# Bowdens Proposal: Hydrogeology

IPC 15 Feb 2023

Lue Action Group

Craig Flavel - Field Development Planning

Figure 3: SW-NE Cross Section Source: GoogleEarth 2022

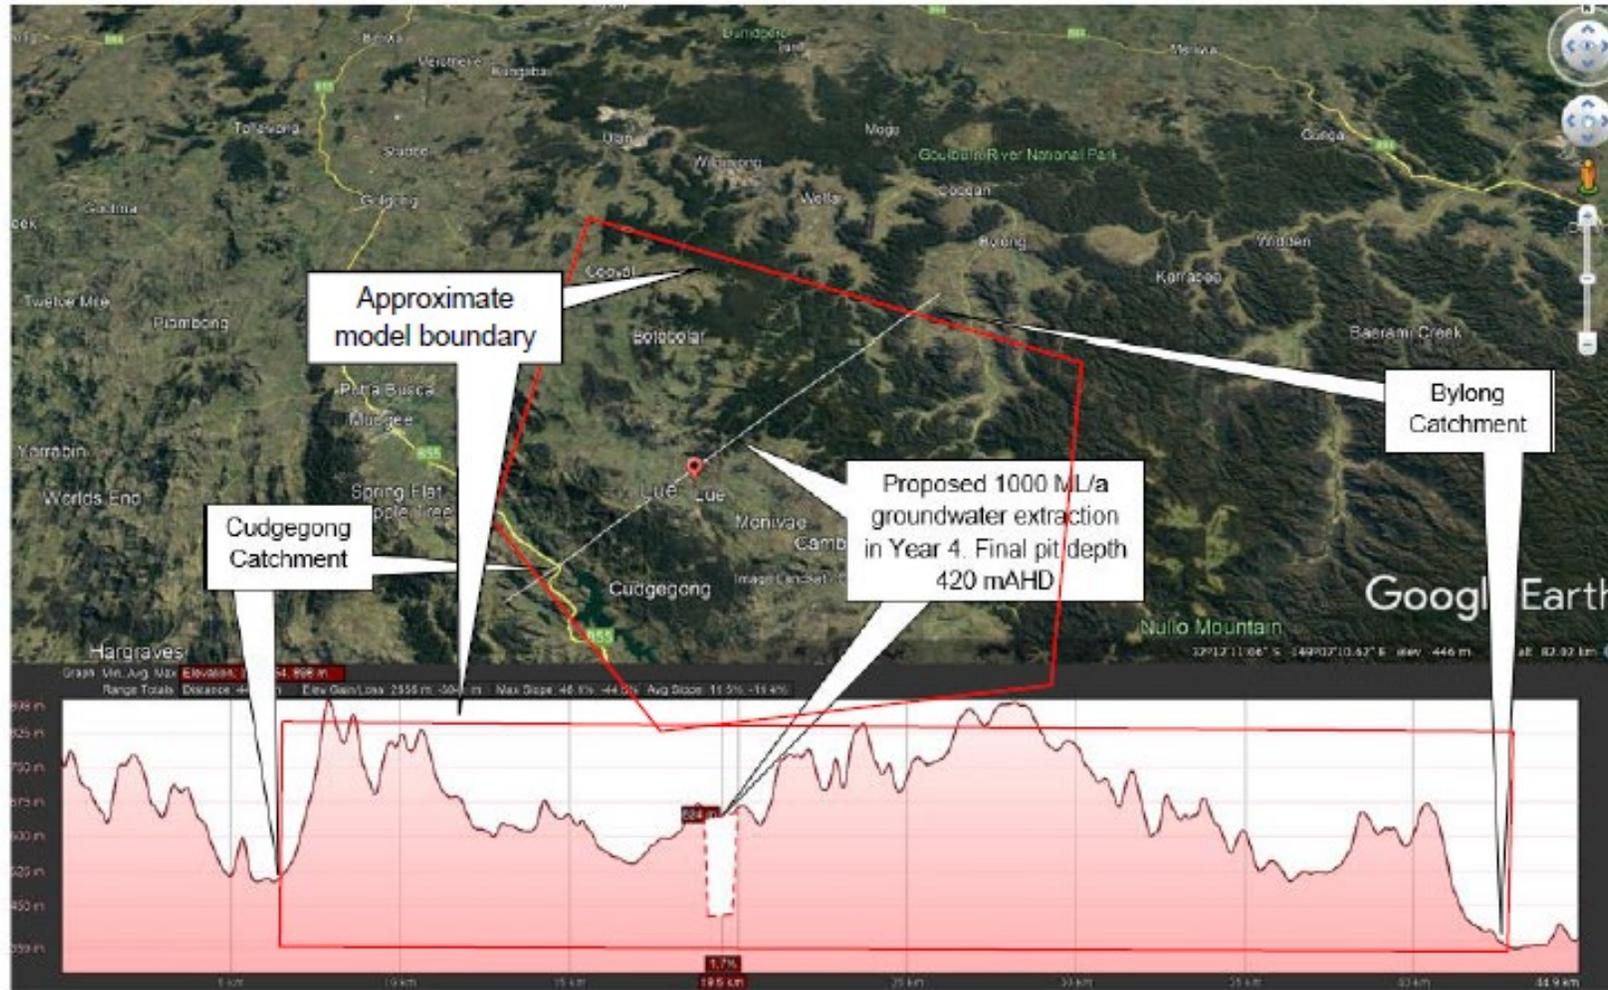
‘no water quality impacts beyond 40 m from the Mine Site boundary and no changes to the beneficial uses of aquifers are predicted’

# 40 m in Context: potential to alter regional hydrology

Figure 4: Site Geology, adapted from (R.W. Corkery & Co., March 2022c, pp. 2-10)

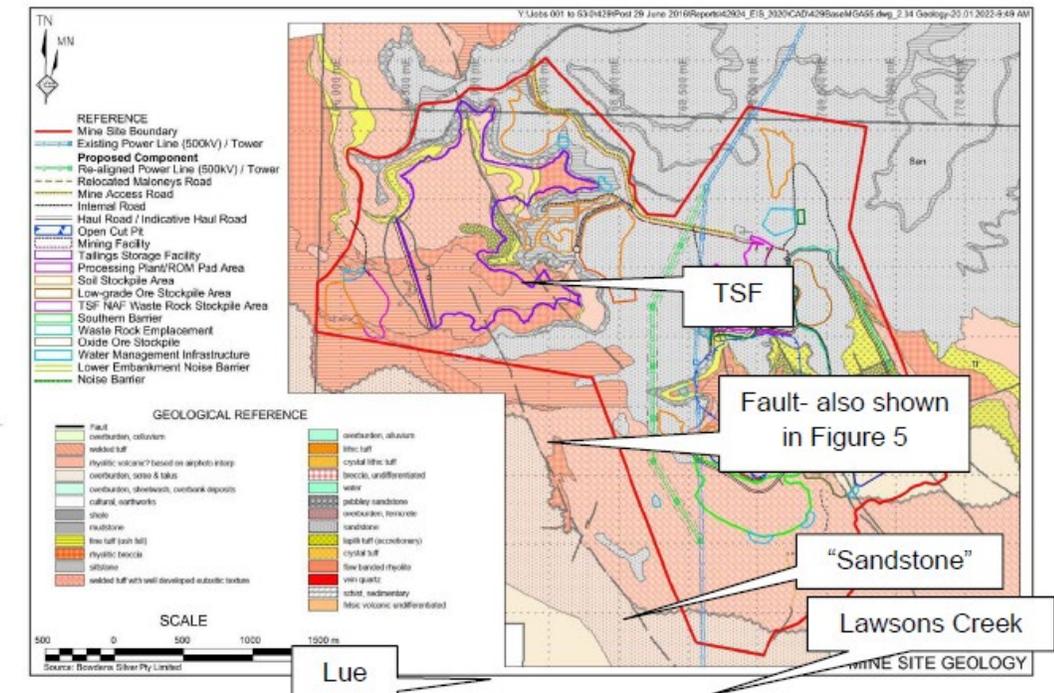
1. R.W. Corkery & Co. A4 (Feb 2022): enhanced permeability within fractured rock aquifers near major geological structures

1. AIP 14: there is potential for causing and enhancing hydraulic connections that has not been clearly presented.
2. AIP Table 4: potential unquantified water quality impacts on nearby licensed groundwater users

Figure 6: Modelled thickness of combined Layers 1 and 2

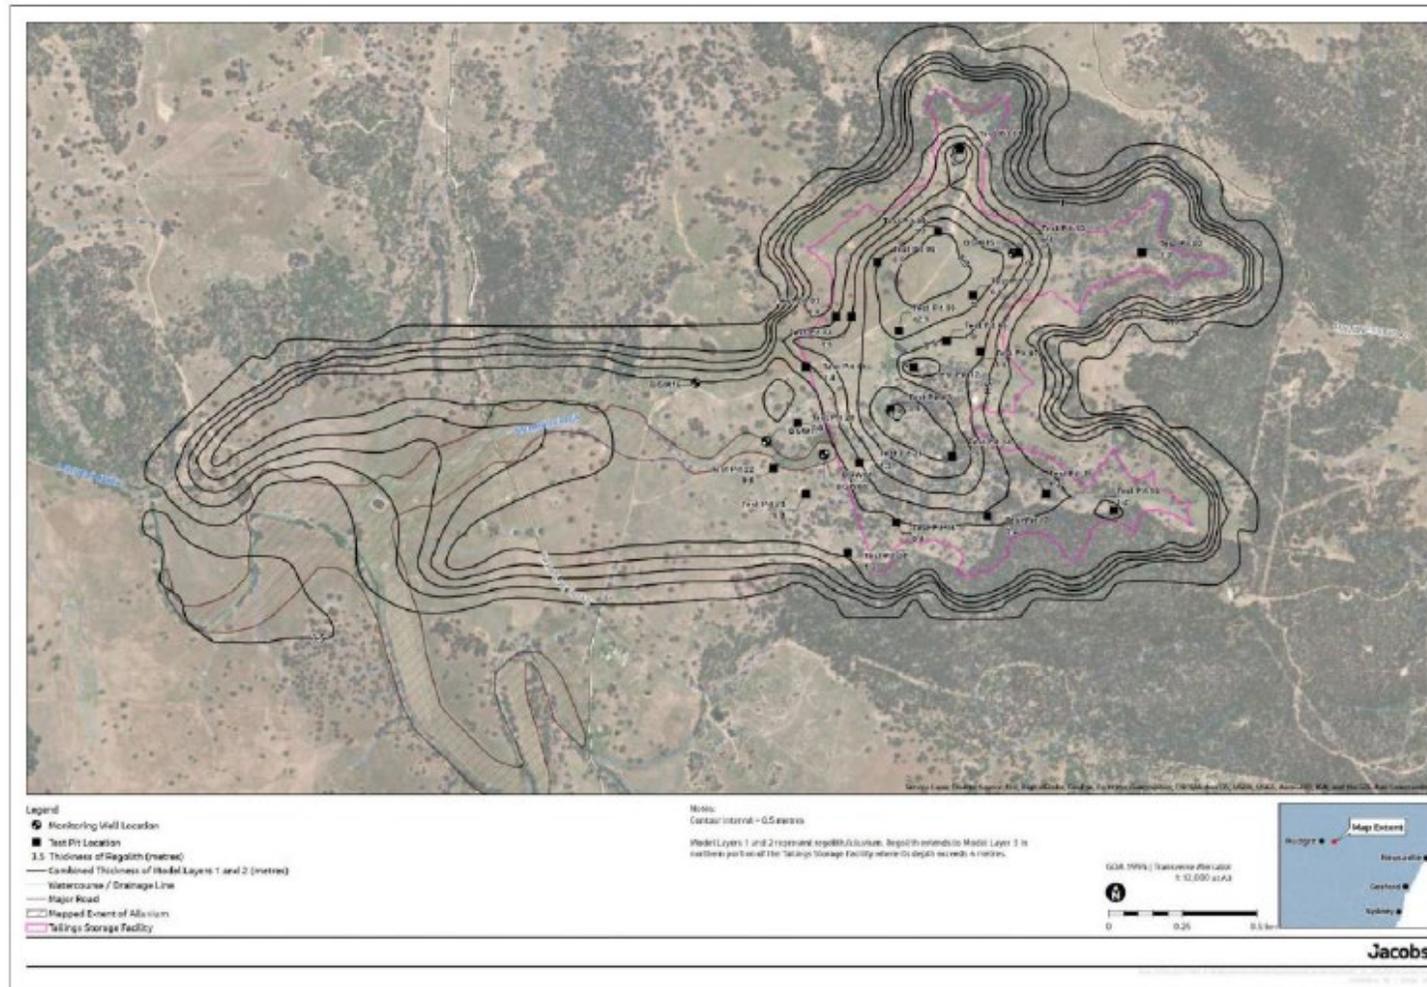
1. The post mining groundwater flows are **unlikely** to be towards the pit  
(R.W.Corkery & Co. Dec 2022 & HydroGeoLogic Dec 2022)
2. Significant and unexplained alterations to model Layer 1 and 2 were made around the TSF in 2022 (HydroGeoLogic 2022)

# Hydrogeological Model Relayering for 2022

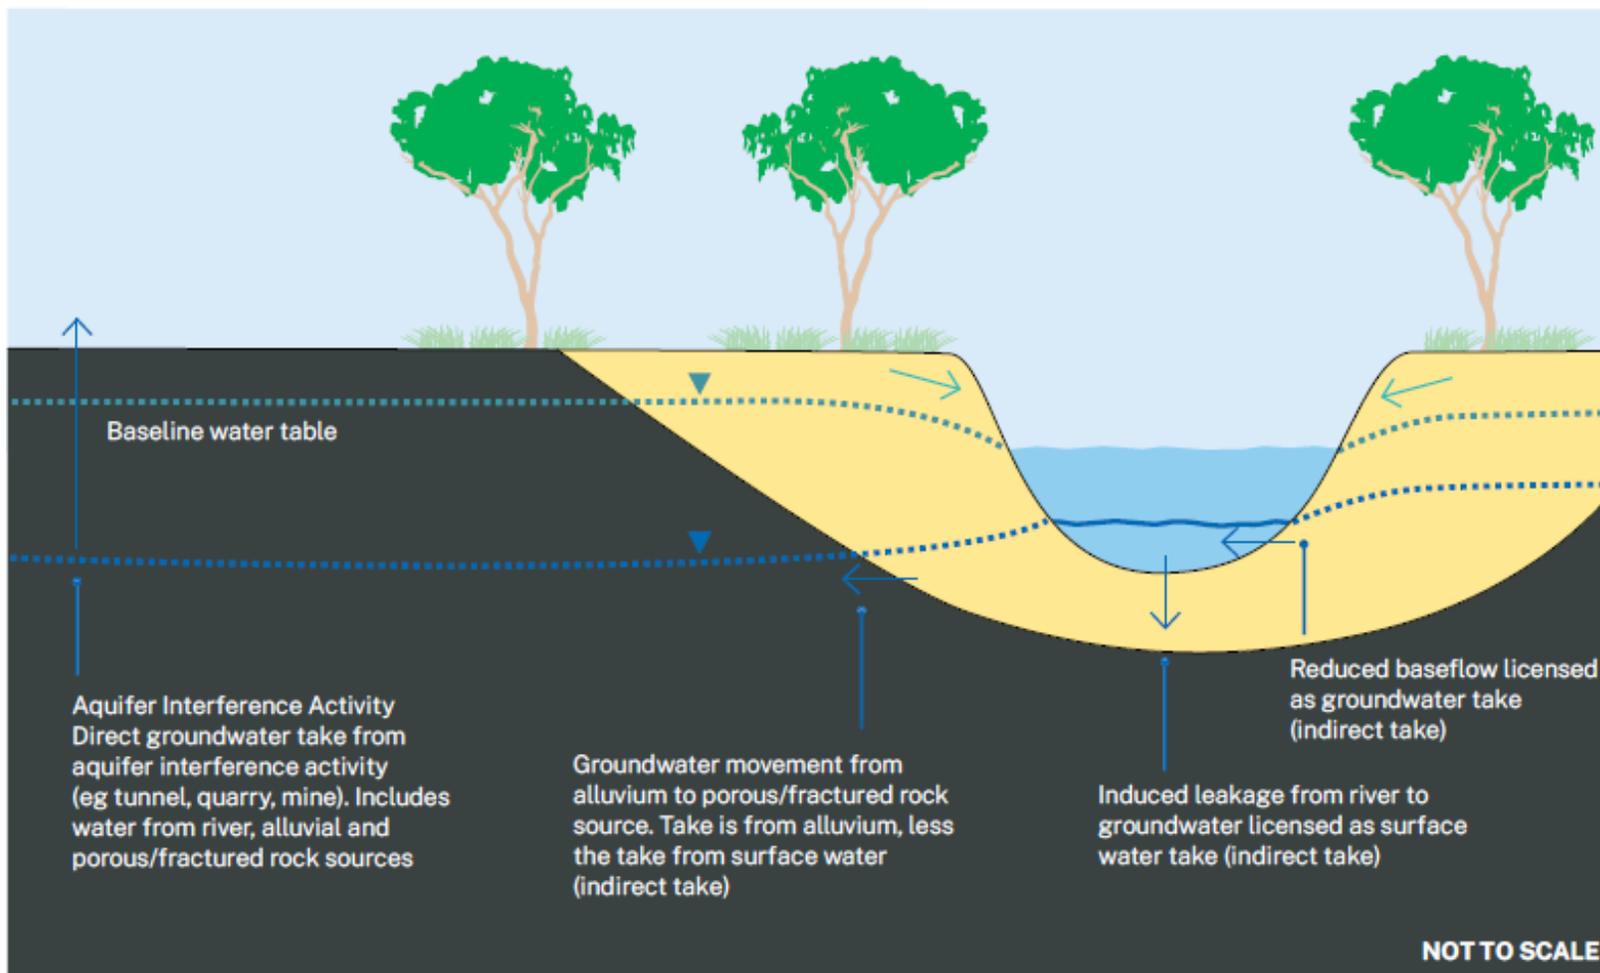
1. Potential seepage is predicted from the TSF and WRE (and Leachate Dam)  
(Jacobs 2020, 5-125)
2. 200 litres/day of seepage under the (ANCOLD 2012) TSF embankment  
(ATC Williams, 2020, p.24)
  1. The nature, mass or attenuation of contaminants leaching from the TSF or WRE to the south and west of the site after 100 years has not been provided.
  2. Seepage collection is uncertain in fractured rock aquifers.
  3. Long term management and response has not been specified
3. Amendment 2-45: An *unconditional* commitment to applying a bituminous liner to the entire area *and* monitoring integrity *and* specific response would help limit seepage

Adapted from HydroGeoLogic, 10 Dec 22 p.11 & 26

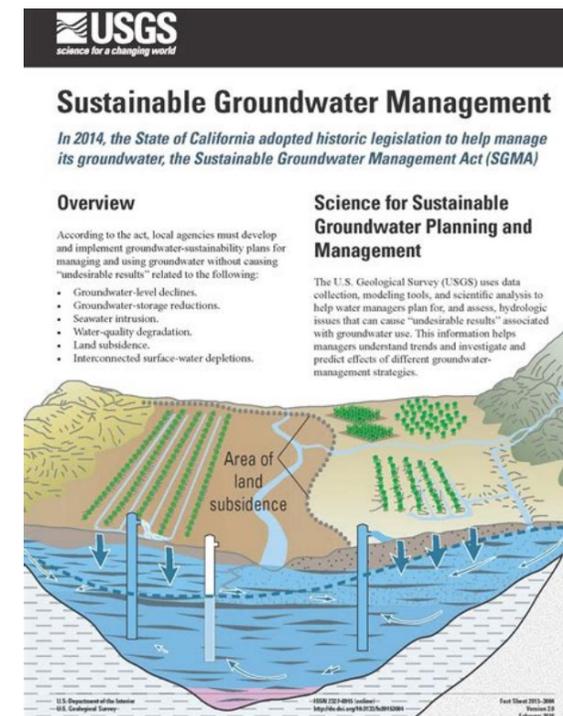
1. Investigating significant groundwater dependent ecosystems would enable an effective monitoring plan.
2. No locations, quantities, controls or triggers for monitoring bores are provided (R. W. Corkery & Co., 2022d, pp. 5-149),
4. A peer reviewed AS/NZS ISO 31000:2009 Risk Assessment would assist

The likelihood of contamination from the final void lake warrants a source-pathway-receptor assessment
